City of Portland, Maine – Building or Use Permit Application 389 Congress Street, 04101, Tel: (207) 874-8703, FAX: 874-8716

Location of Construction: <i>124 W. Shore Drive Lot 12 Diamond Cove CD</i>		Owner: <i>Edward Vinhel</i>		Phone: <i>207-874-4305</i>		Permit No: 001103	
Owner Address:		Lessee/Buyer's Name:		Phone:		BusinessName:	
Contractor Name: <i>442 North Atlantic Custom Builders</i>		Address: <i>442 North Atlantic Custom Builders 1973 Portland ME 04101</i>		Phone: <i>284-0824</i>		Permit Issued: SEP 28 2000	
Past Use: <i>vacant</i>		Proposed Use: <i>single family</i>		COST OF WORK: \$ <i>500,000</i>		PERMIT FEE: \$ <i>2,024</i>	
Proposed Project Description: <i>NEW single family</i> <i>Kevin Tracy</i> <i>831-39470</i>		FIRE DEPT. <input type="checkbox"/> Approved <input type="checkbox"/> Denied		INSPECTION: Use Group <i>A-3</i> Type <i>5B</i> <i>BOC 199</i>		Zone: <i>RE-1</i> CBL: <i>0438-1-012</i>	
		Signature:		Signature: <i>[Signature]</i>		Zoning Approval: <i>[Signature]</i>	
		PEDESTRIAN ACTIVITIES DISTRICT (P.A.D.) Action: <input type="checkbox"/> Approved <input type="checkbox"/> Approved with Conditions <input type="checkbox"/> Denied		Signature: _____ Date: ____

SK-3

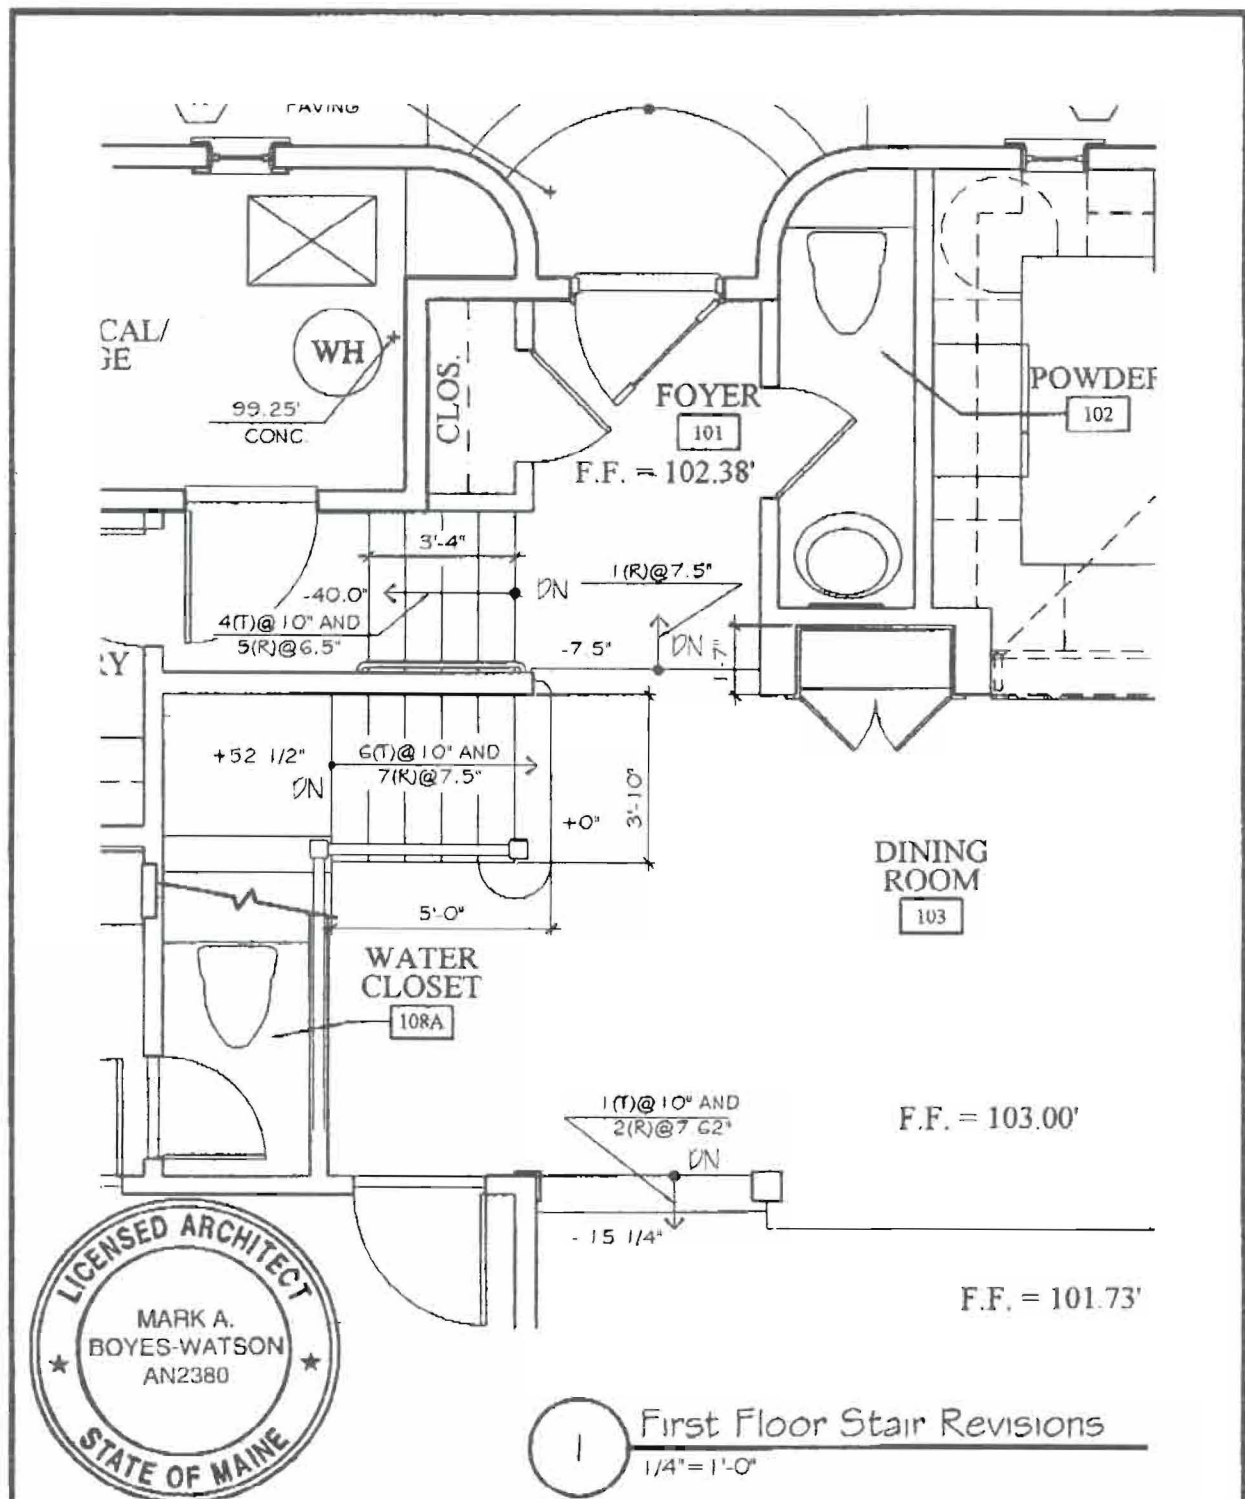
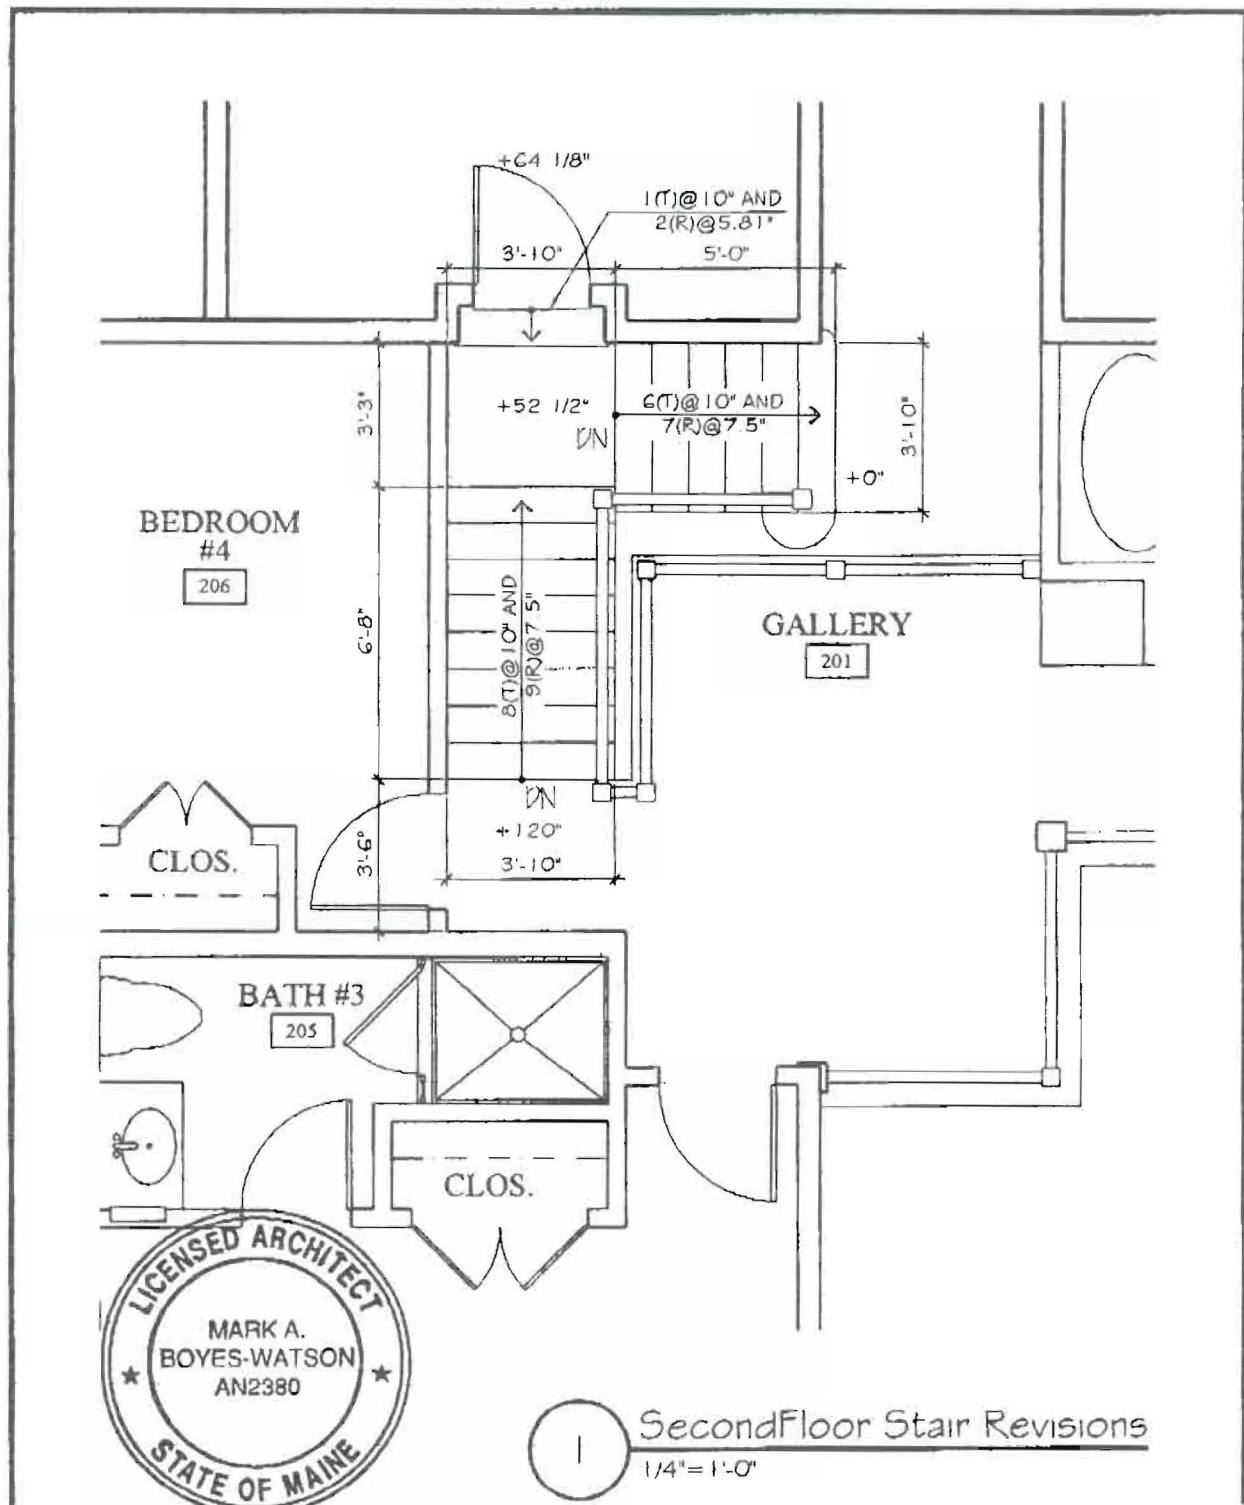
5/9/01 Framing, Plumbing, electric. Stair stringers 9" cut. Explained that they must be 10" net tread. Egress windows only 5'4" (30.5 x 25.75) Need specs on 1st Floor Beams. Does not have 2" clearance around chimney

Per your request the stair will be revised as indicated in our sketches to meet B.O.C.A. National Building Code Standards.

Please find attached revised drawings for the Main Stair in the Finkel Residence at Lot 12 Diamond Cove.
